## SUPPLEMENTARY AGENDA 31 JANUARY 2024 ATTACHMENTS

<b>11.2 DEVELOPMENT APPLICATION - DA23/0327 - SINGLE HOUSE (SWIMMING POOL, GYM &amp; GARAGE) - SPECIAL CHARACTER AREA AT LOT 16 (NO. 6) SEAVIEW RISE, EAGLE BAY.....</b>	<b>2</b>
11.2.1 ATTACHMENT 1 - SITE LOCATION PLAN.....	2
11.2.2 ATTACHMENT 2 - DEVELOPMENT PLANS.....	3
11.2.3 ATTACHMENT 3 - AERIAL INDICATING BUILDING SETBACK LINE FROM EAGLE BAY ROAD.....	12
11.2.4 ATTACHMENT 4- OFFICER ASSESSMENT REPORT.....	13
11.2.5 ATTACHMENT 5 - SCHEDULE OF SUBMISSIONS.....	51
11.2.6 ATTACHMENT 6 - PERSPECTIVES PLAN.....	61
<b>16.5 NOTICE OF MOTION - CITY OF BUSSELTON PLANNING APPROACH.....</b>	<b>62</b>
16.5.1 STATE PLANNING AND DEVELOPMENT FRAMEWORK.....	62
16.5.2 STRATEGY PLAN - GEOGRAPHE BAY.....	63

## SPECIAL CONTROL AREA ASSESSMENT SHEET

APPLICATION DETAILS	
APPLICATION No.	DA23/0327
PROPOSAL	Single House (Swimming Pool, Gym and Outbuilding) - Special Control Area
LOCATION	Lot 16 No 6 Seaview Rise EAGLE BAY WA 6281
APPLICANT	Joe Ferrant
OWNER	C Leo, K Fallace, L Fallace
DISCRIPTION OF PROPOSAL	The proposal comprises a mainly two storey dwelling with a three storey section (where the garage in partiality below ground level on the no

LANDSCAPE DEVELOPMENT APPLICATION

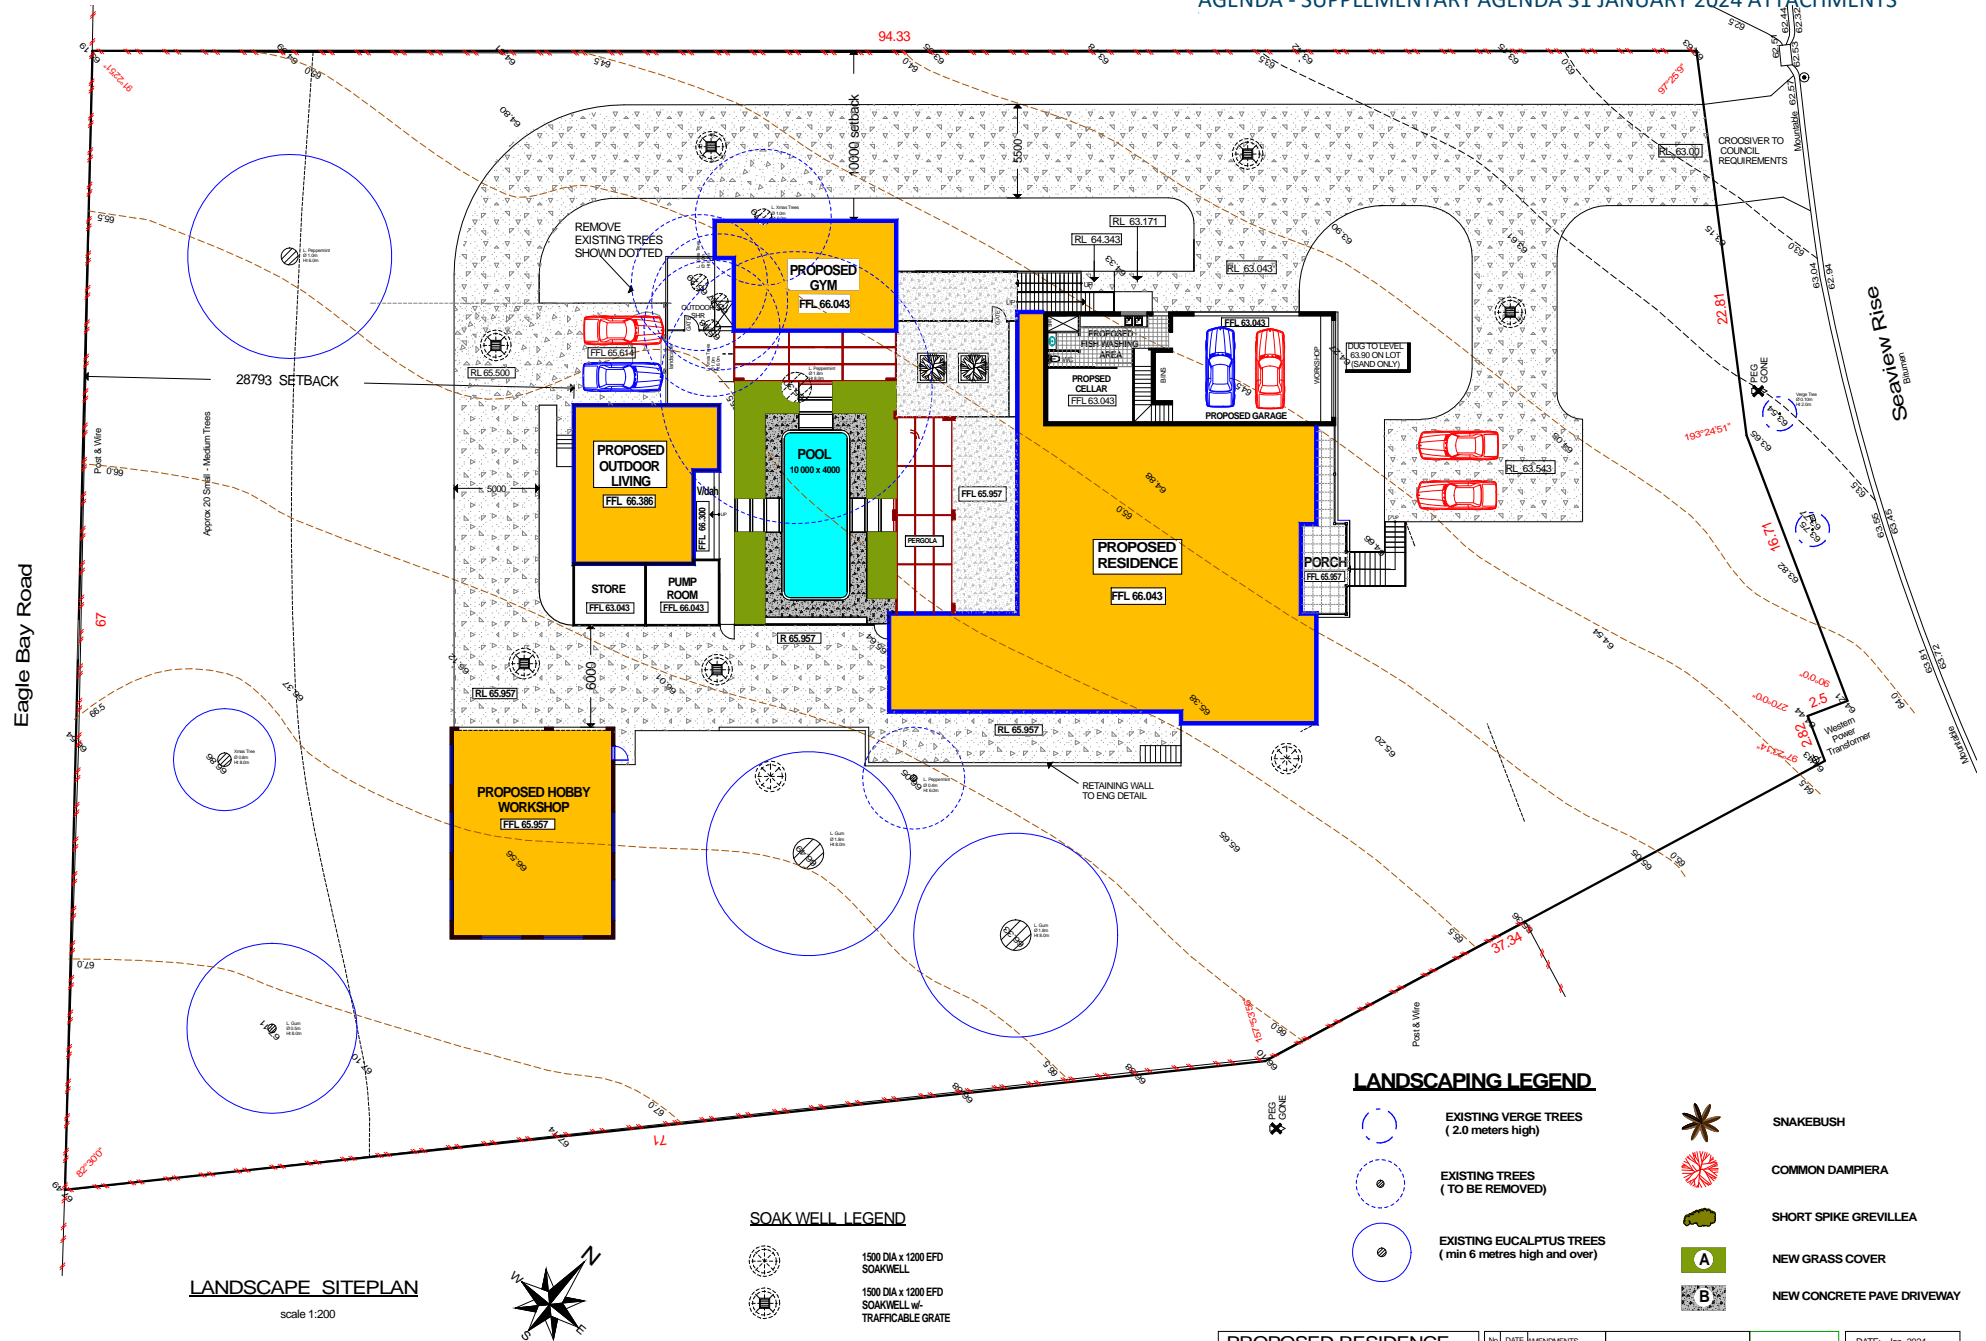
Landscaping plan provided – Officer satisfied that the landscaping plan addresses the reduced setback with a mix of trees and plants endemic to SW of WA and will grow to heights sufficient for effective screening.

#### Eagle Bay Structure Plan: 2007

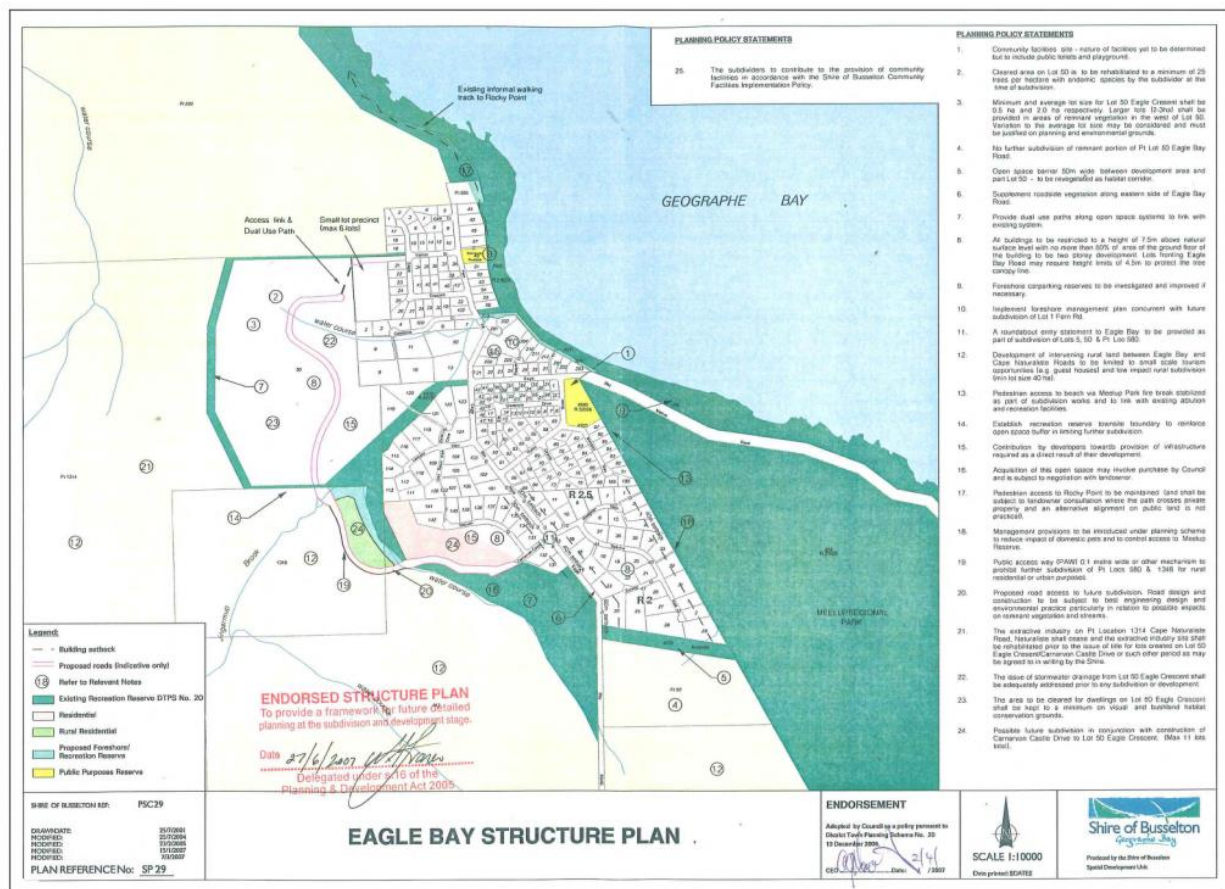
In relation to Building Height - Provision 8 of the Structure Plan states as follows:

- All buildings to be restricted to a height of 7.5m above natural surface level with no more than 50% of area of the ground floor of the building to be two storey development. Lots fronting Eagle Bay Road may require height limits of 4.5m to protect the tree canopy line.

In relation to setbacks, the structure plan map depicts a 40m setback from Eagle Bay Road for the four lots marked as 38, 16, 17 and 23.

The structure plan is a “due regard” planning instrument, therefore discretion to vary setback to 22m.

#### Previously endorsed Structure Plan (DGP 20) Seaview R:2003

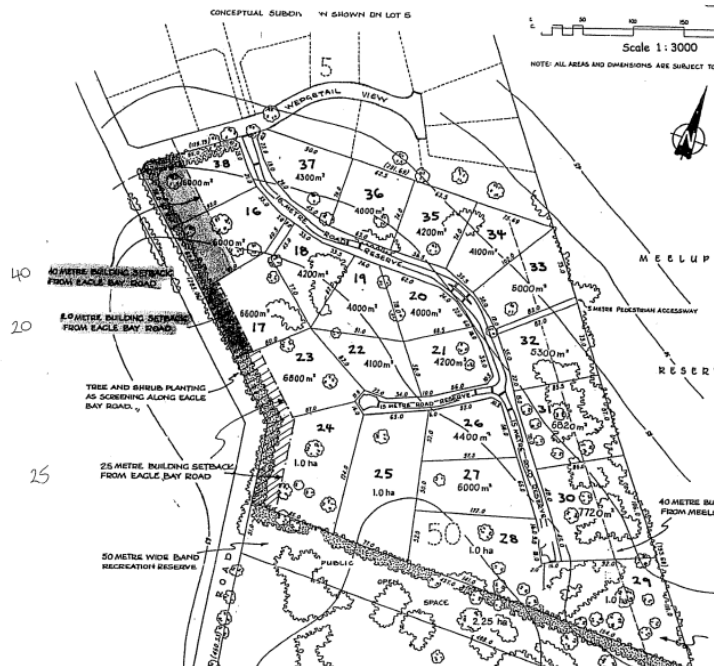
DGP 20 shows variable setbacks for several lots adjacent to Eagle Bay Road (ie 20m, 25m, and 40m); the more recent structure plan has a uniform 40m setback. This has resulted in anomalies in the streetscape, with existing buildings having a <40m setback. Properties with <40m setbacks have implemented a landscaping buffer. A Landscaping plan has been provided and it provides an acceptable buffer.

**Survey Plan**

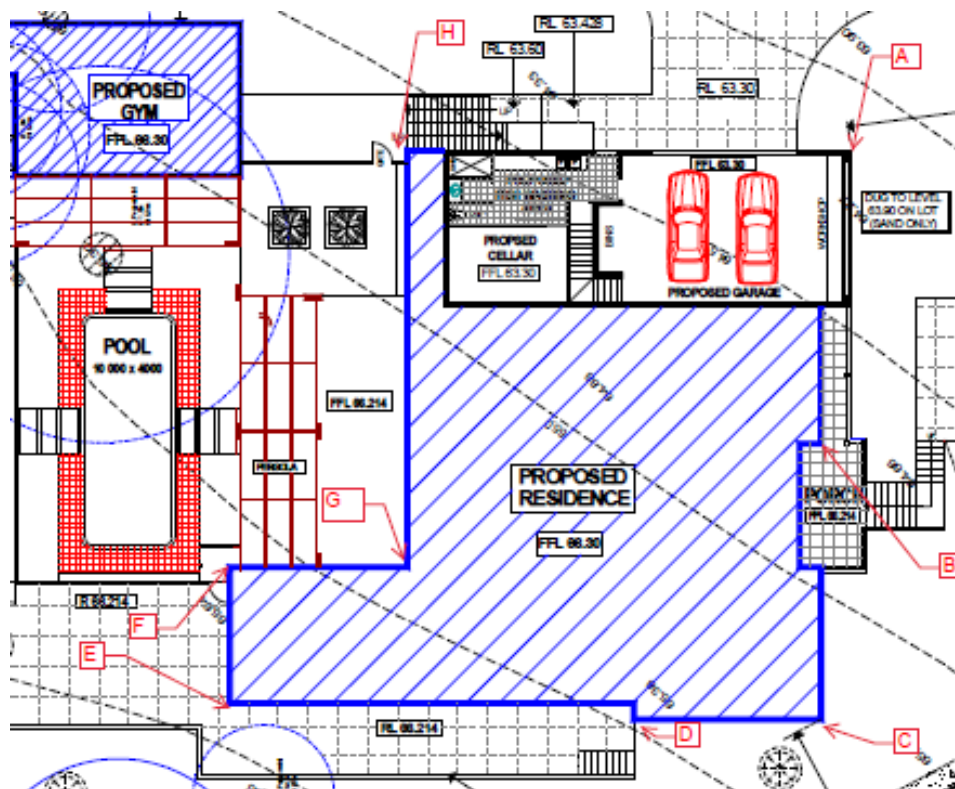
The lot levels taken from the site survey and as such are used for all building height calculations as per the definition of *Natural Ground Level* from the R-Codes. (See table below for height calculations)

The site is over 150 metres (Approx. 730m) from the MHW. The MHW is defined by the scheme as follows:

**Extract from Plans – Annotated Building Height**

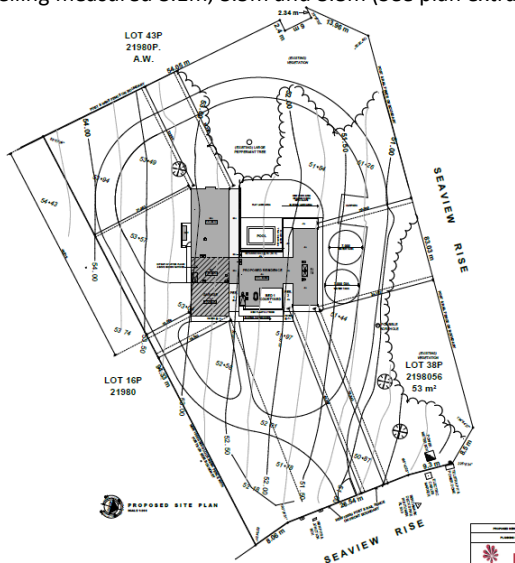
POINT	NGL	FIRST FLOOR FFL	ROOF RL	MAXIMUM HEIGHT PROPOSED	COMPLIES
A	63.9m	69.129m	72.6m	8.7m	Yes
B	64.5m	69.129m	72.65m	8.15m	Yes
C	65.2m	69.129m	72.82m	7.62m	Yes

D	65.5m	69.129m	75.52m	7.32m	Yes
E	66.0m	69.129m	72.5m	6.5m	Yes
F	65.5m	69.129m	72.3m	6.5m	Yes
G	65.5m	69.129m	72.5m	7.4m	Yes
H	64.5m	69.129m	72.8m	8.3m	Yes

The entire lot is subject to the 8.7m building height limit and as demonstrated above is compliant.

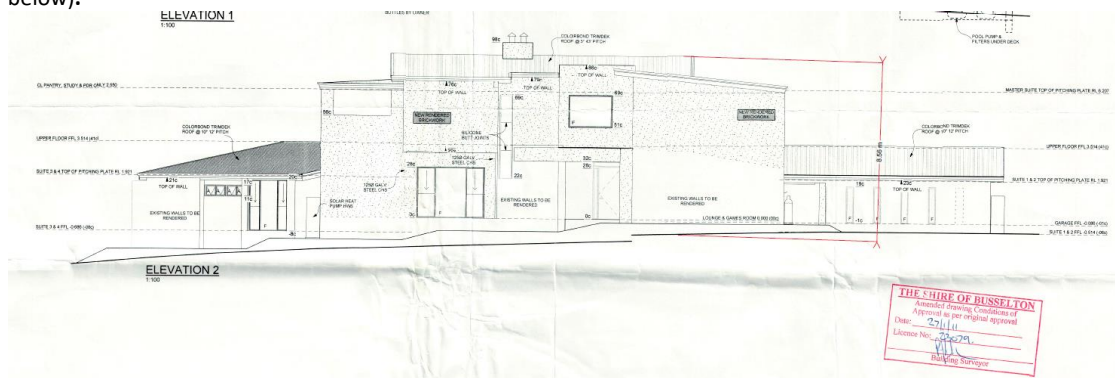
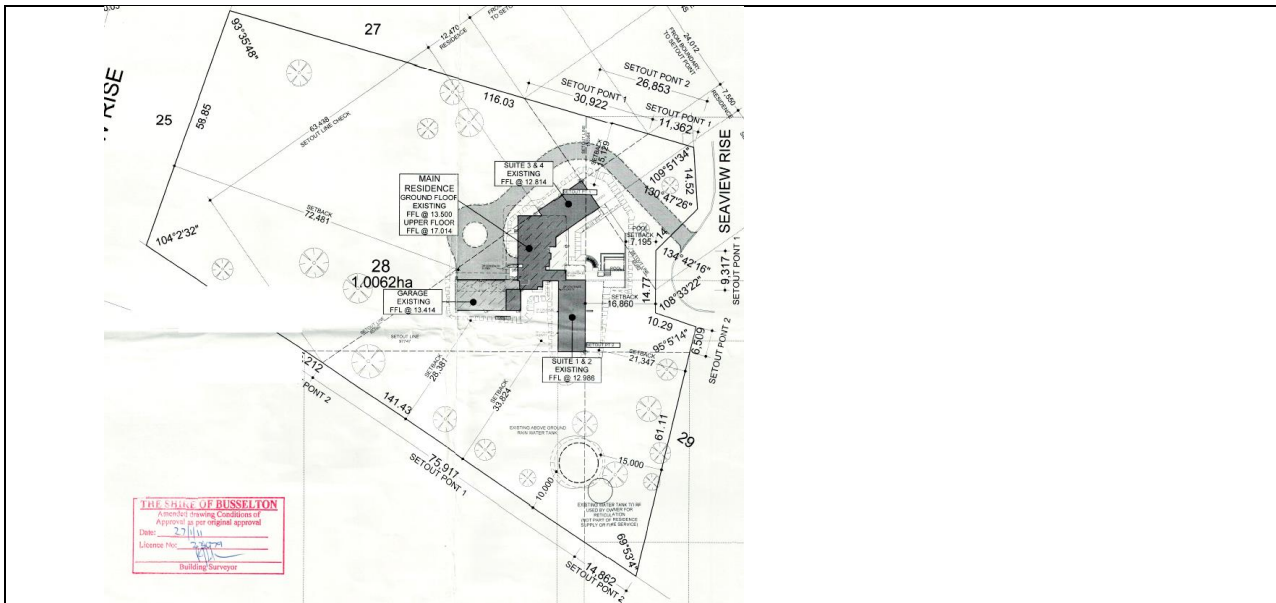
The Structure Plan states that no more than 50% of area of the ground floor of the building to be two storey. The habitable building consist of a main residences outdoor living area/games room and gym. The areas are broken down as follows:

<b>Areas</b>	
Garage/cellar	114.83m <sup>2</sup>
<b>Ground Floor</b>	<b>402.89m<sup>2</sup></b>
Porch/balcony	86.15m <sup>2</sup>
Gym	69.00m <sup>2</sup>
Outdoor House	80.00m <sup>2</sup>
Store/Pump rm	31.21m <sup>2</sup>
Outdoor Garage	227.54m <sup>2</sup>
<b>Total Ground Floor/</b>	<b>1011.62m<sup>2</sup></b>
Cellar	
<b>Upper Floor</b>	<b>224.52m<sup>2</sup></b>
Top Deck	120.42m <sup>2</sup>
<b>Total Upper Floor</b>	<b>344.94m<sup>2</sup></b>
<b>Total Area</b>	<b>1356.56m<sup>2</sup></b>

As such it is considered that the two storey/upper floor area of 224m<sup>2</sup> is not more than 50% of the ground floor of this property.

re 1: Classified Vegetation

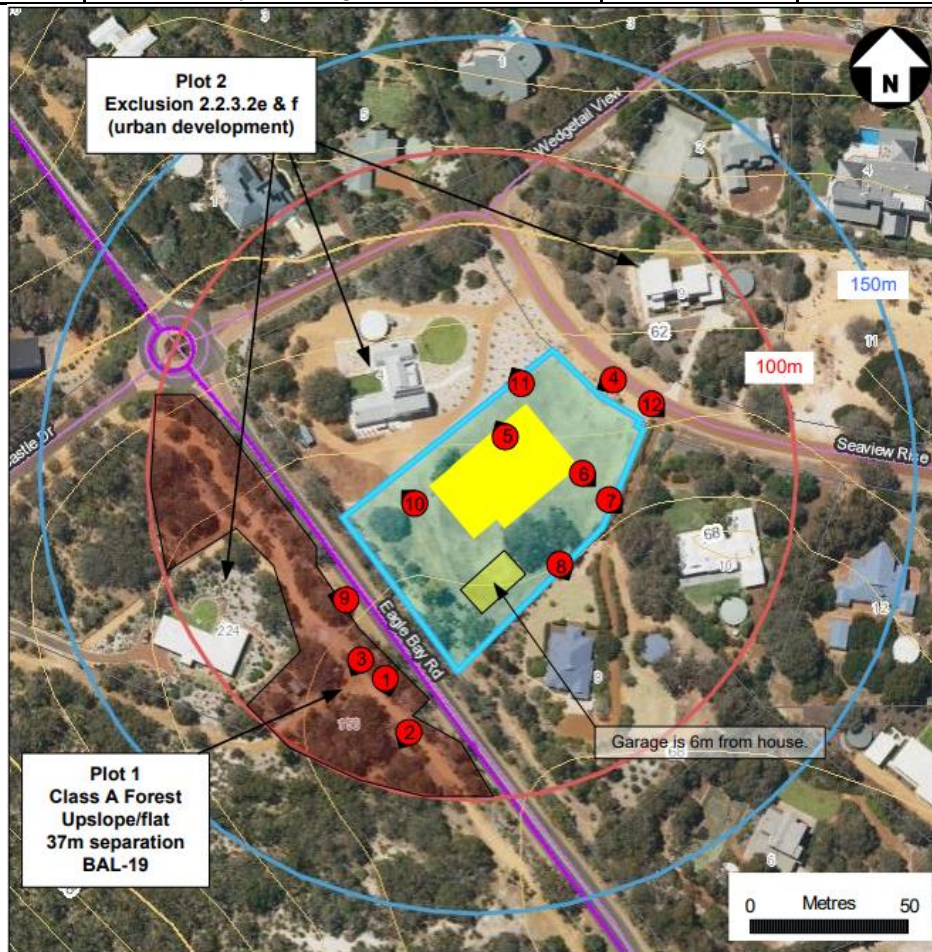
Historical Aerials show this as a cleared site approx. 10 year ago.

The site is Classified as a Firebreak Category 2

It has been confirmed by the Rangers Department (18/07/23) that this site is inspected every year to enforce the firebreak notice and that this site has complied every year. Therefore the city can accepted that site being excluded from the vegetation classification map provided by the Bushfire consultant as set out above.
